# section 7

**SCHEMATIC CHANGES**

Figure 7-1. 75S-3B/3C Receiver, Schematic Diagram (Sheet A)

Figure 7-1. 75S-3B/3C Receiver, Schematic Diagram (Sheet 1 of 2)

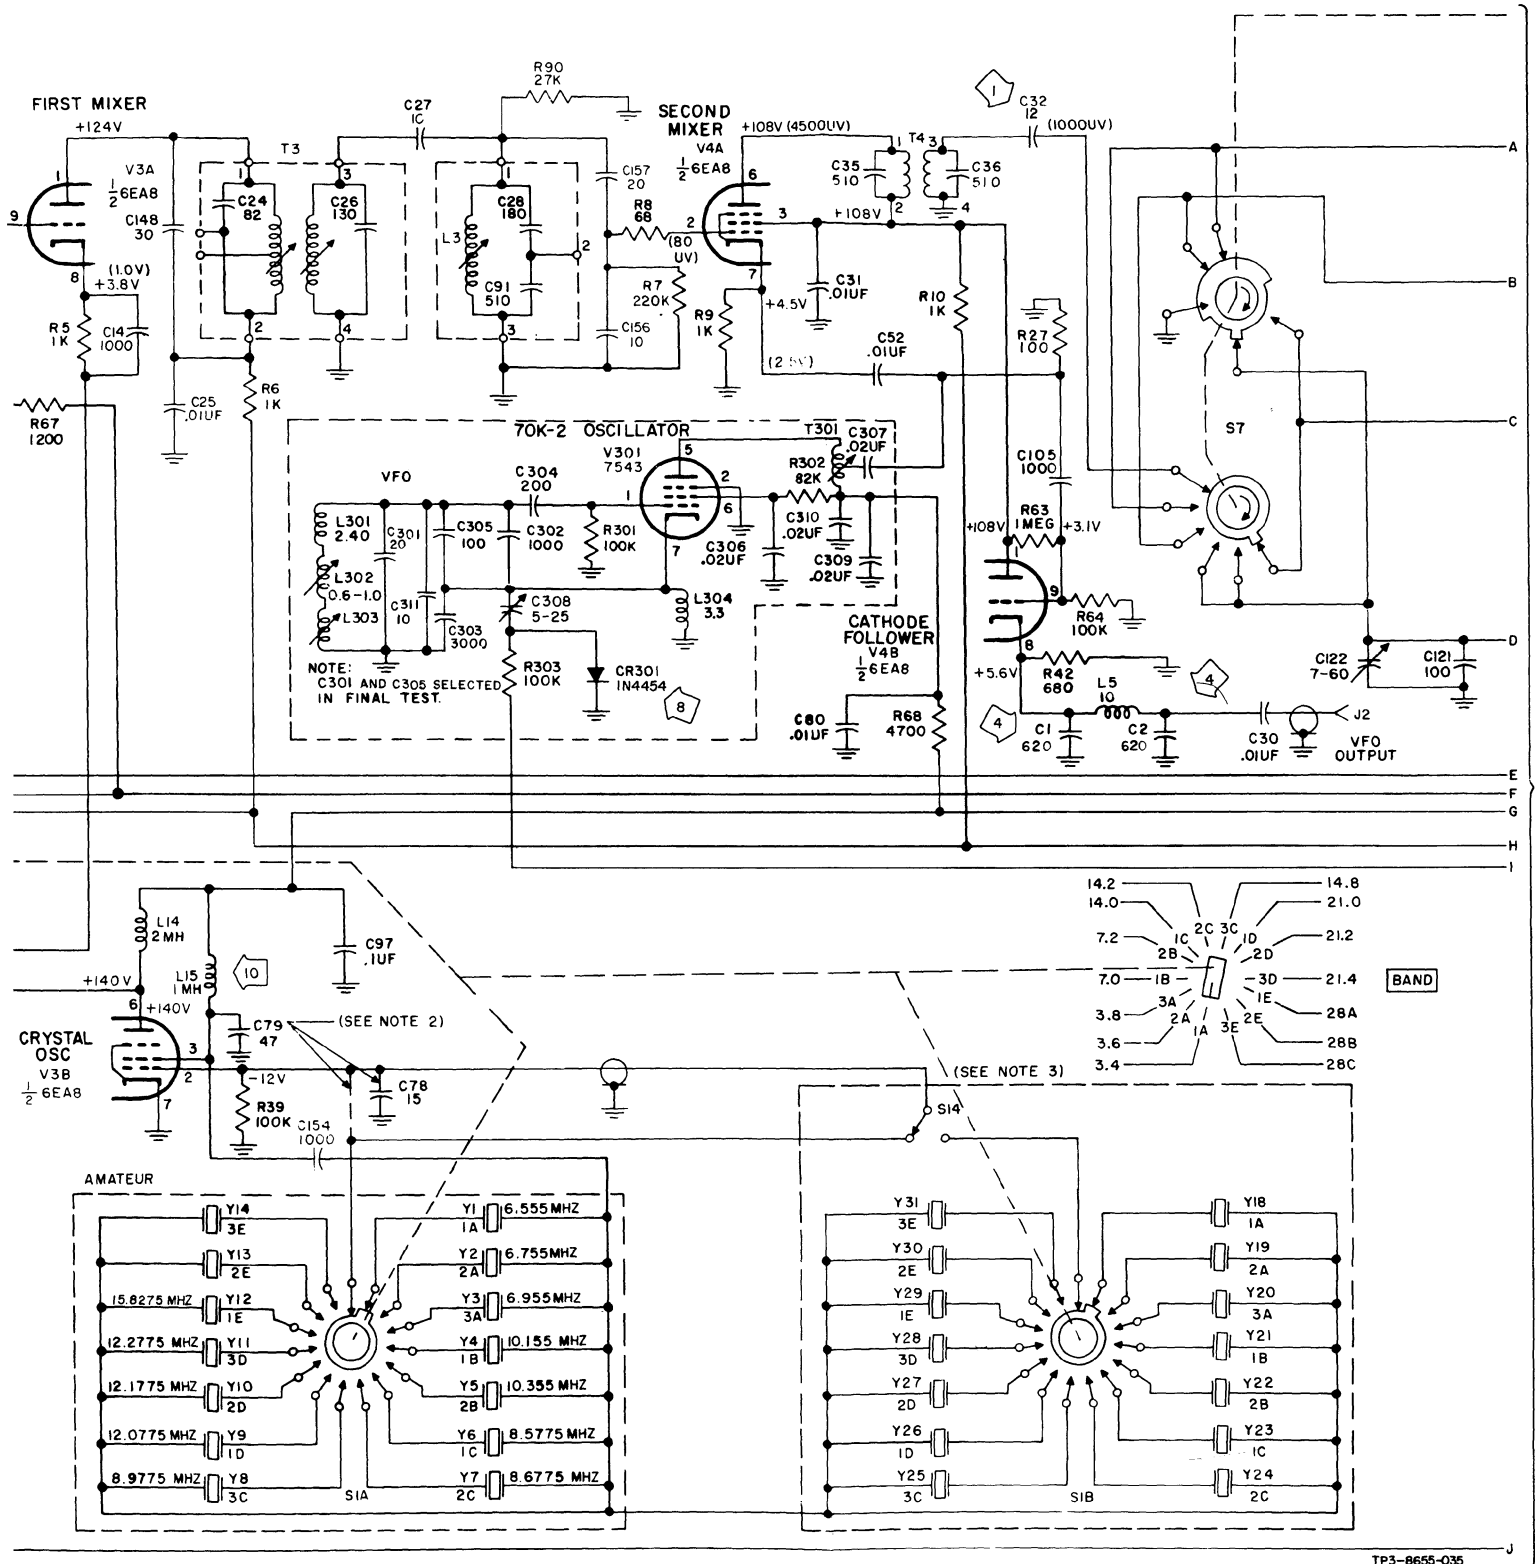
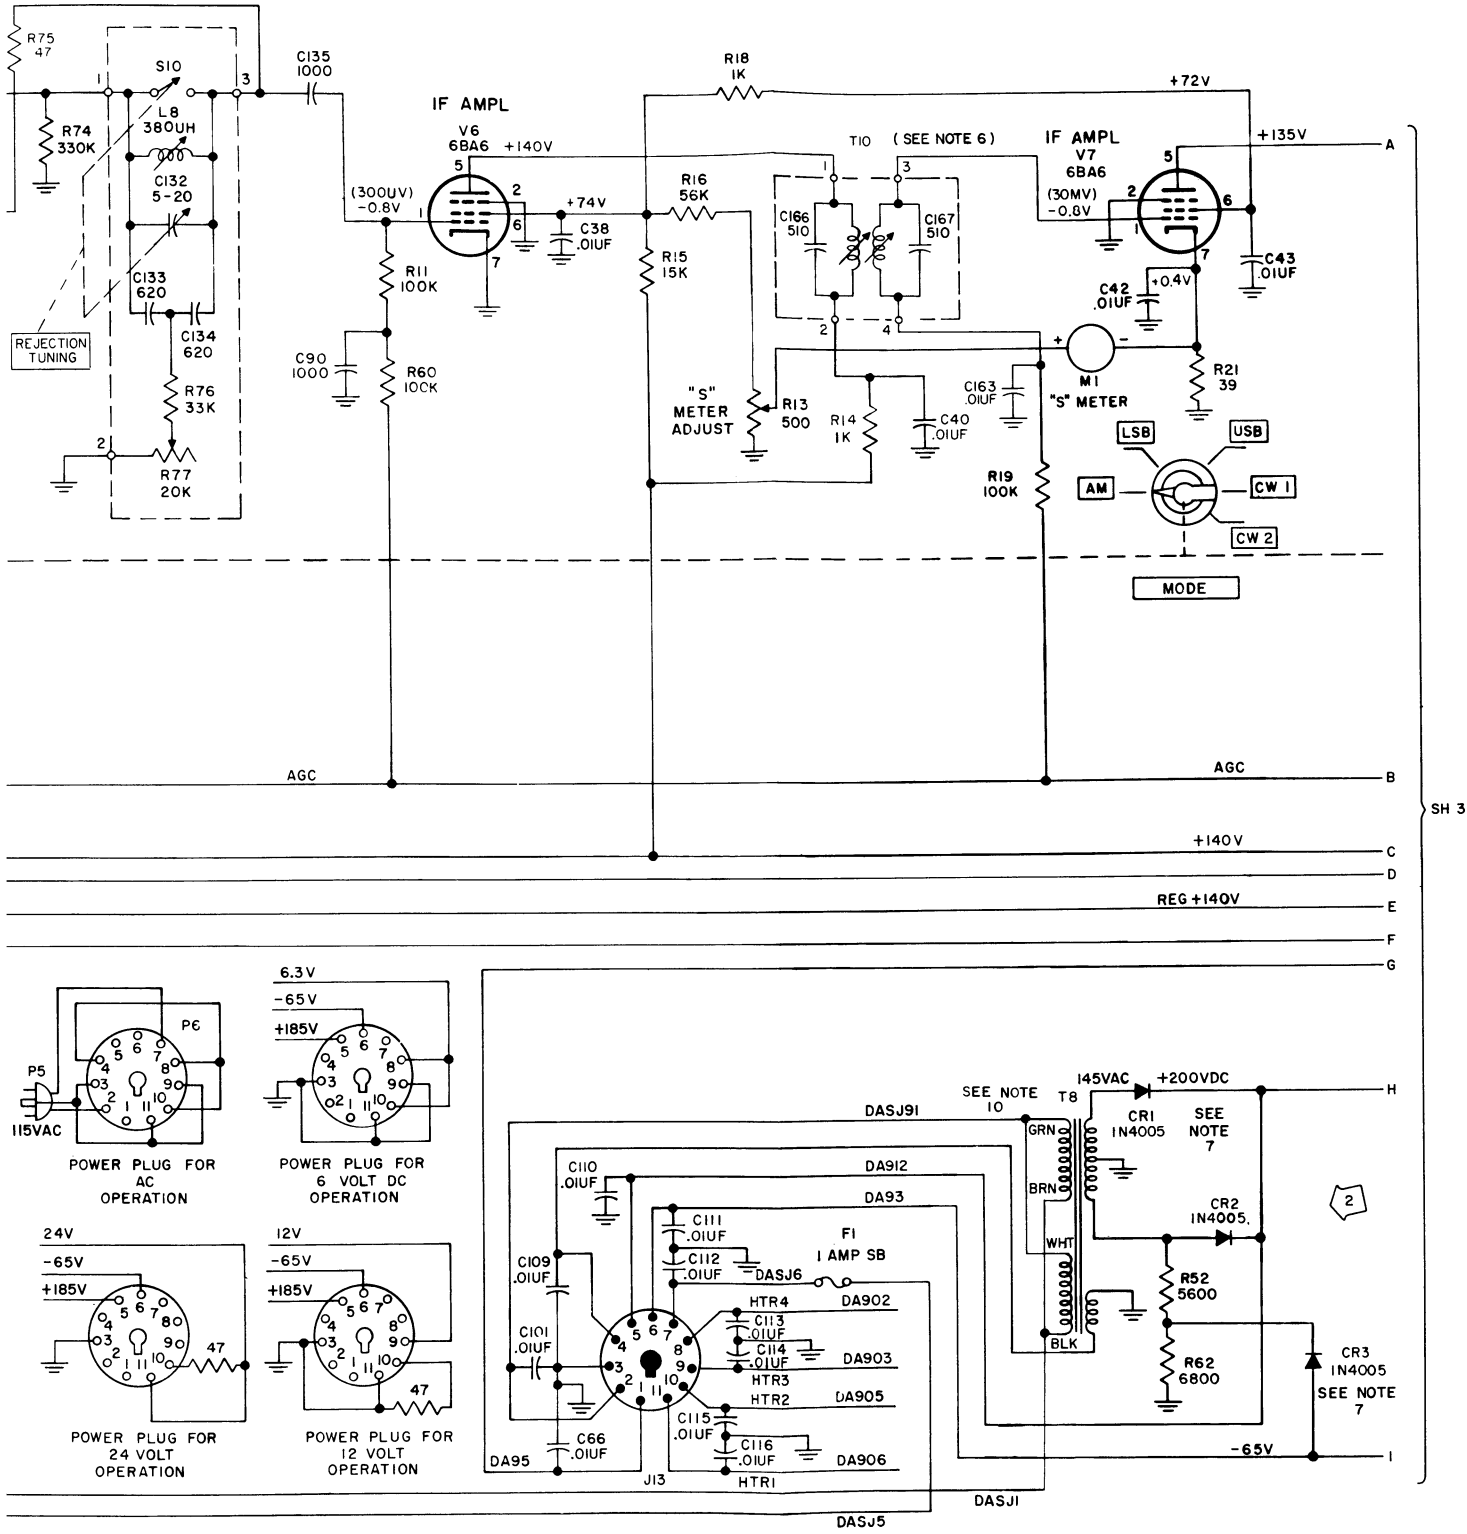
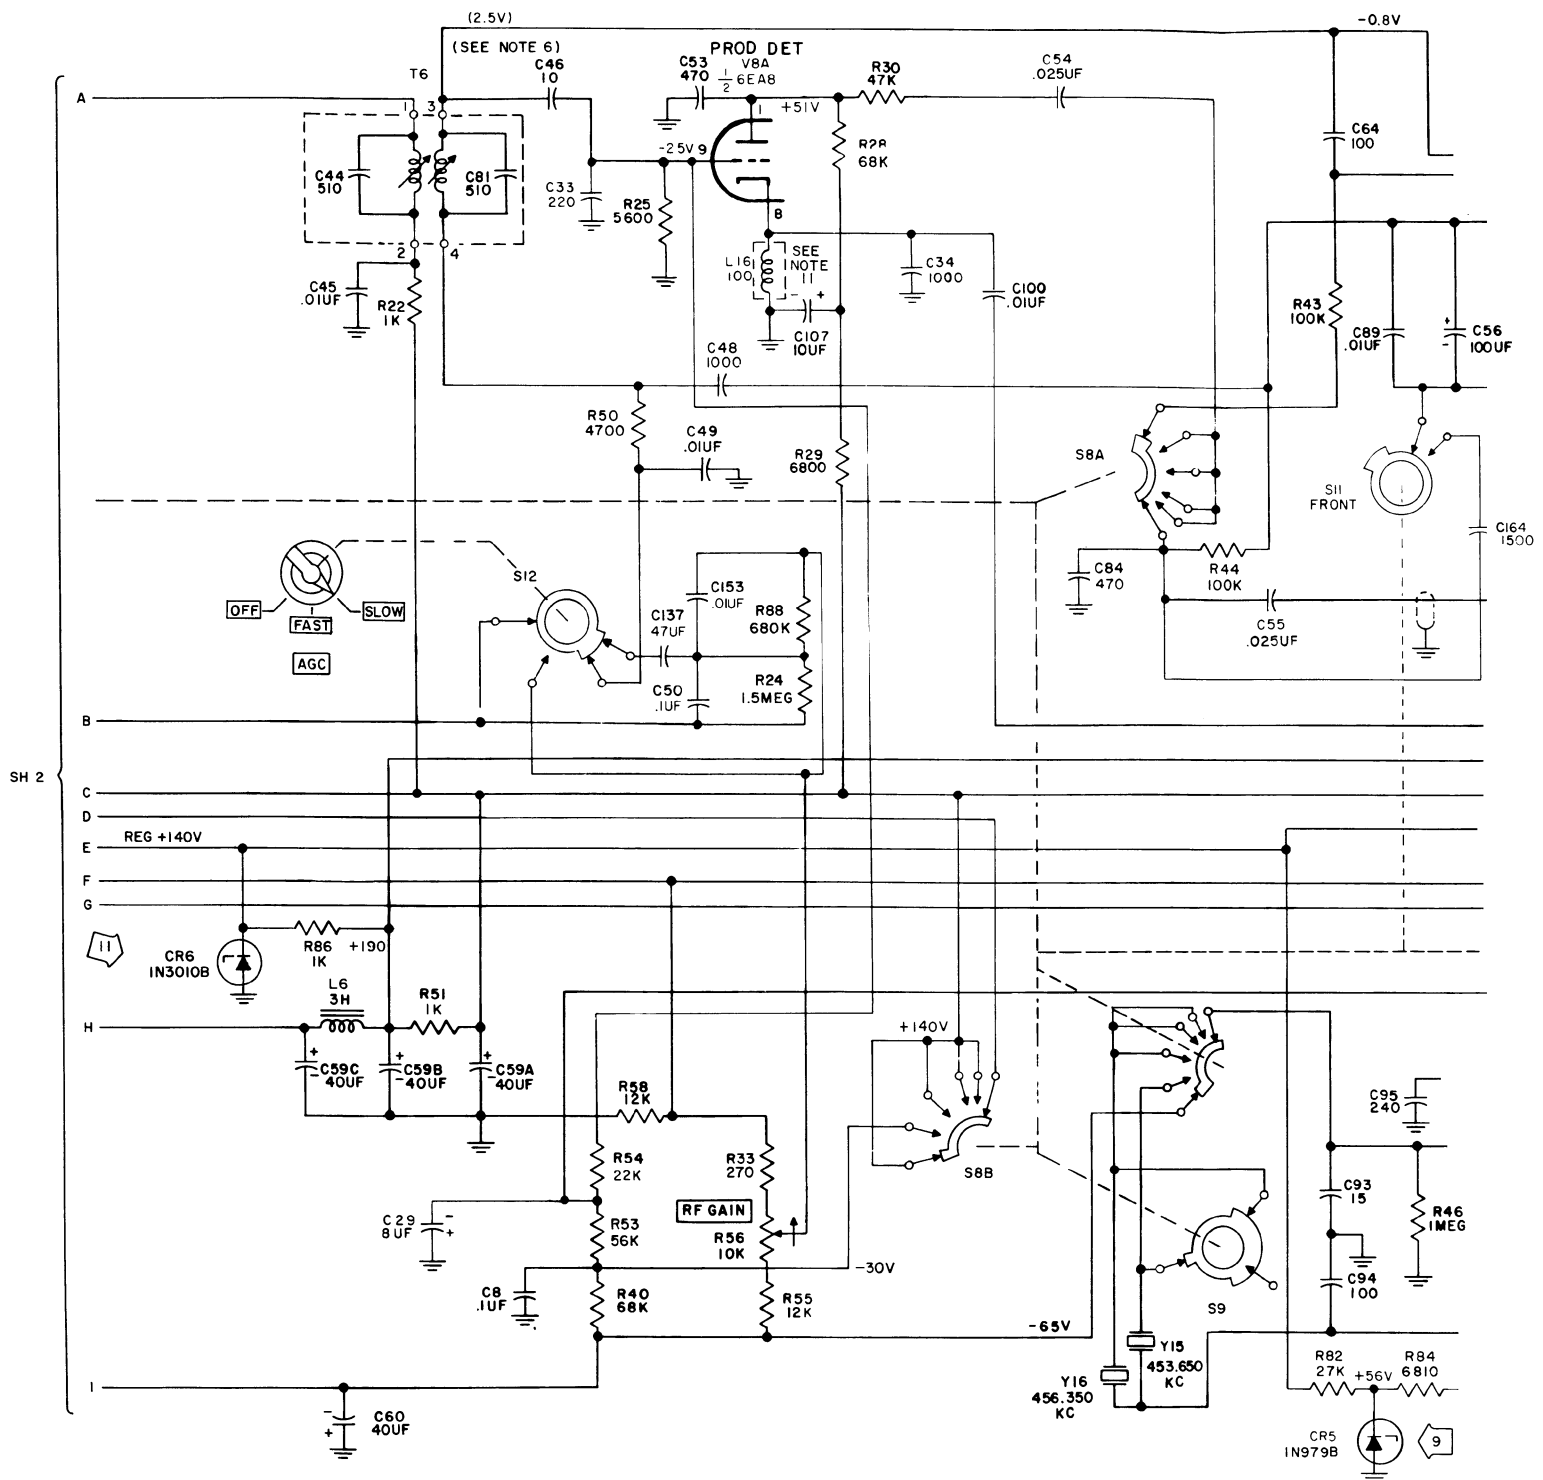
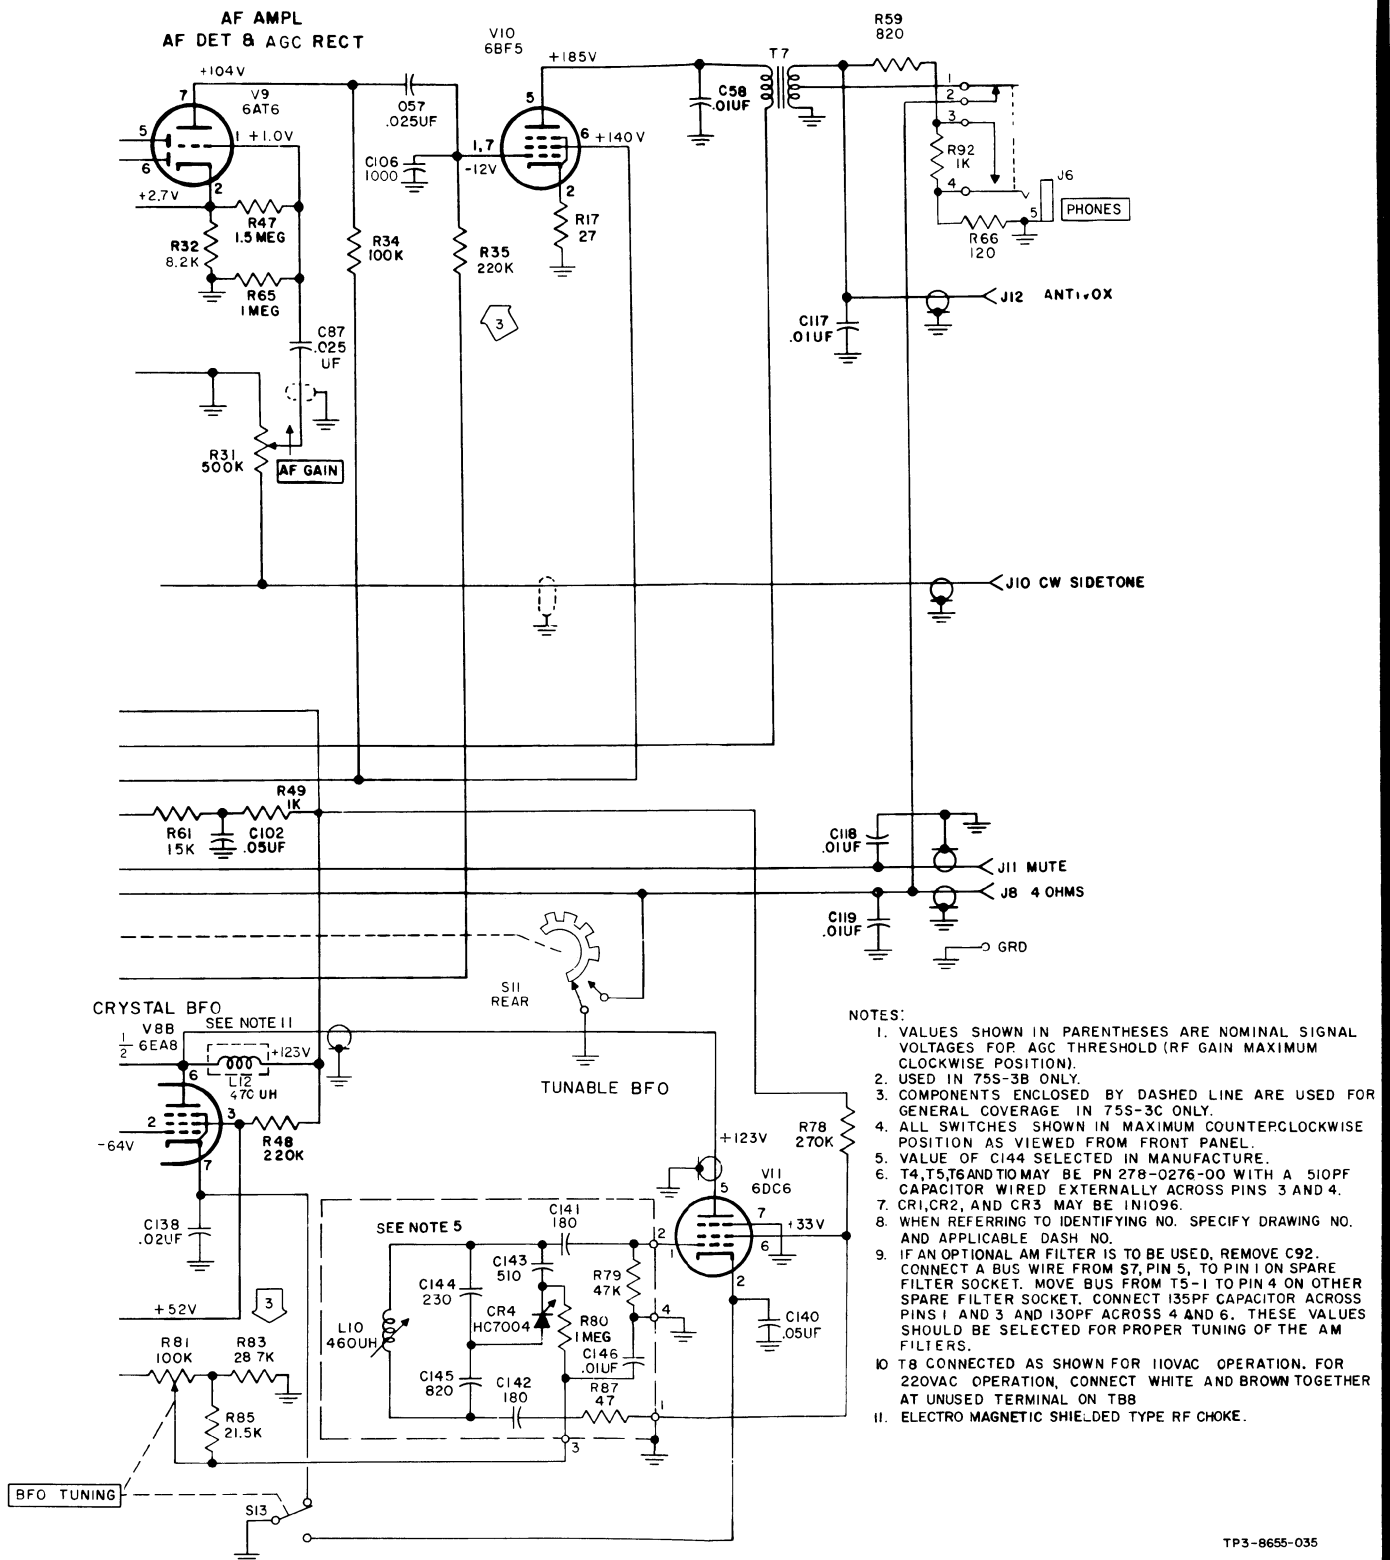
REVISION IDENTIFICATION	DESCRIPTION OF REVISION AND REASON FOR CHANGE	SERVICE BULLETIN	EFFECTIVITY
1	Changed value of C32 from 6 pF to 12 pF to provide tighter coupling between T4 and T5 and between T4 and FL1. An overall increase in gain (approximately 2 dB) should also result from this change.	Na	Na
2	CR1, CR2 and CR3 changed from 1N1492 to 1N4005 for cost reduction.	Na	Na
3	Resistor R83 changed from 17.8 to 28.7 k $\Omega$ and R85 changed from 51.1 to 21.5 k $\Omega$ to provide better tracking of variable bfo frequency with the front panel calibration points.	Na	Na
4	Changed value of C1 and C2 from 510 to 620 to correct low output injection from vfo.	Na	Na
5	Changed C63 from 100 to 510 and changed C61 from 8-50 to 5-25 to improve performance of crystal calibration.	Na	Na
6	Added R94, C168, and CR8 and changed value of C12 from 1 to 3 to improve the crystal calibrator harmonics.	Na	Na
7	Diode CR8 was changed from JAN 1N826 to 1N4454 to improve calibrator output.	Na	Na

8	CR301 in the 70K-2 Oscillator was changed from 1N34A to 1N4454 for greater reliability.	Na	Na

REVISION IDENTIFICATION	DESCRIPTION OF REVISION AND REASON FOR CHANGE	SERVICE BULLETIN	EFFECTIVITY
9	Zener diode CR5 changed from 1N732 to 1N979B due to nonavailability of parts.	Na	Na
10	Changed screen grid choke L15, in hf oscillator from 2 mH to 1 mH to prevent spurious oscillations.	Na	Na
11	Changed zener type to allow tighter tolerances.
